Subject: Geometry overlaps!!!!

It seems that there is a lot of problems in the Panda geometry which cause the simulation to crash specially when using new packages of ROOT and VMC (ROOT 5.23.2, Geant4.9.2.p1, etc). I attached to this mail 2 root files with:

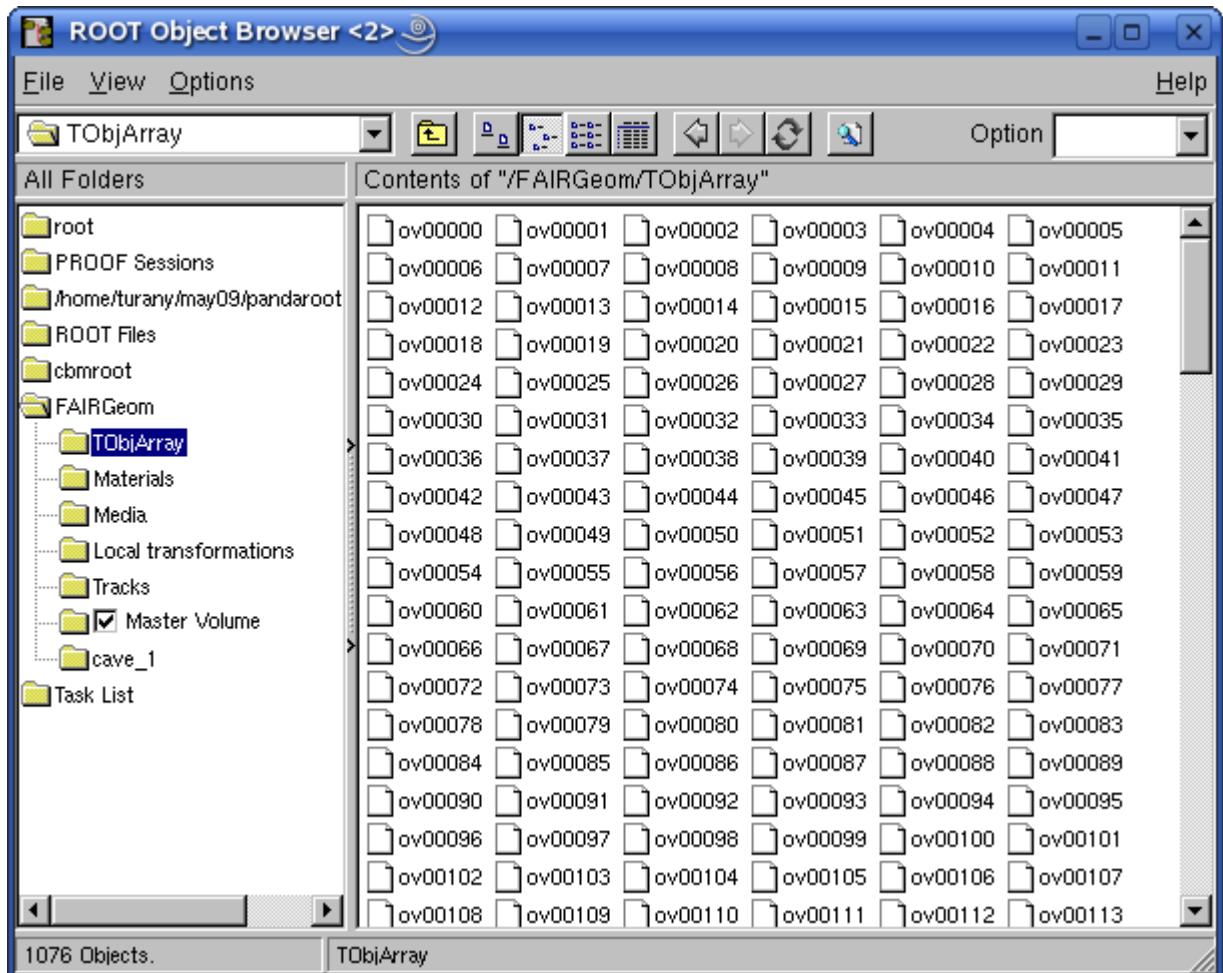
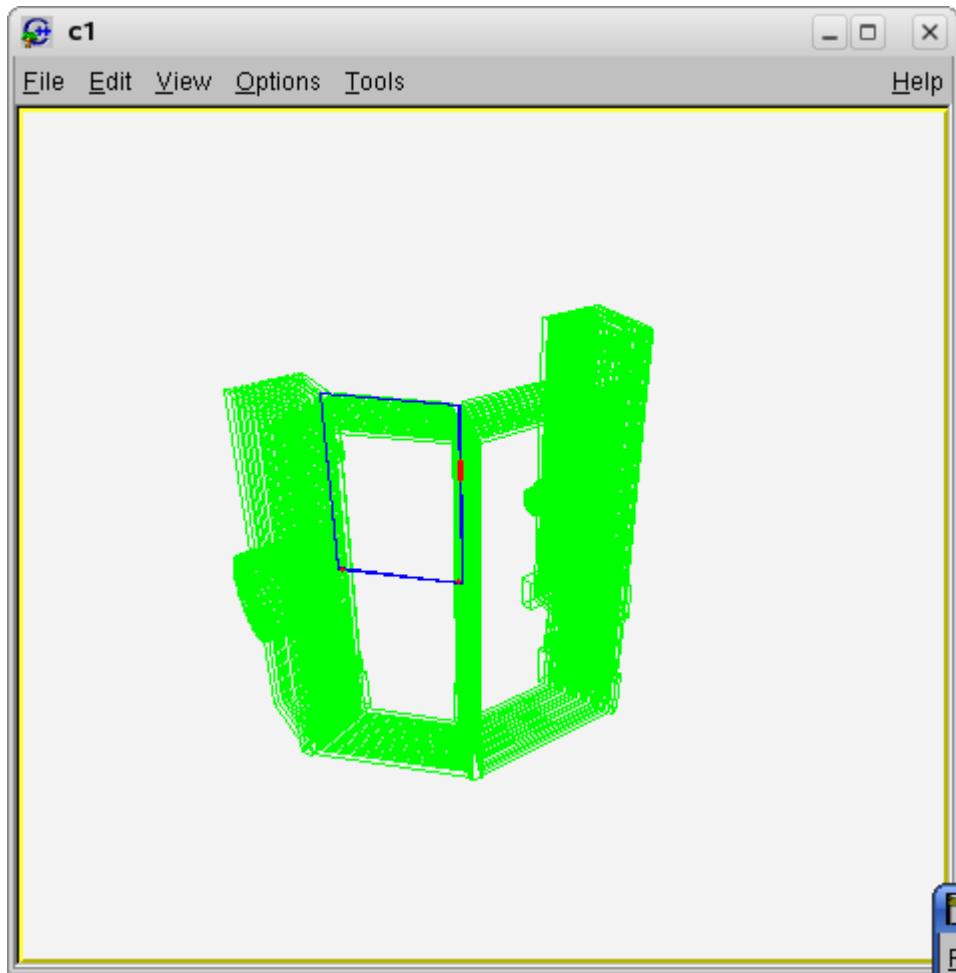
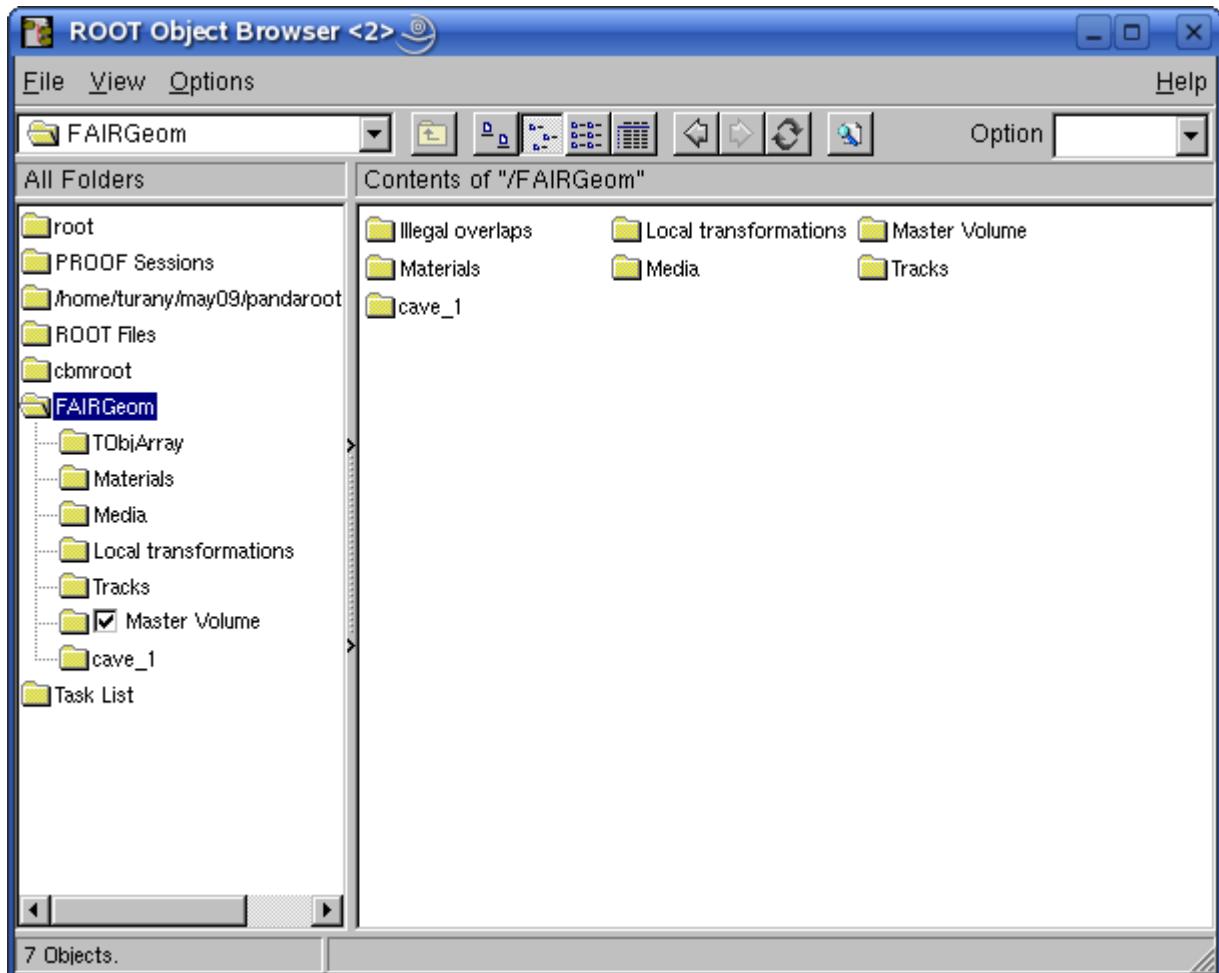
in this file you will see 447 overlaps! mostly between MDT and Solenoid

the same as before with the PandaSolenoidV833.root as geometry file for the Solenoid. This has also 538 overlaps!

if you double klick any of these overlaps you will get some info (names and so on) in the terminal and it will be drawn on a canvas:

Please check this, most of them are small overlaps which could be avoided by using better precision!
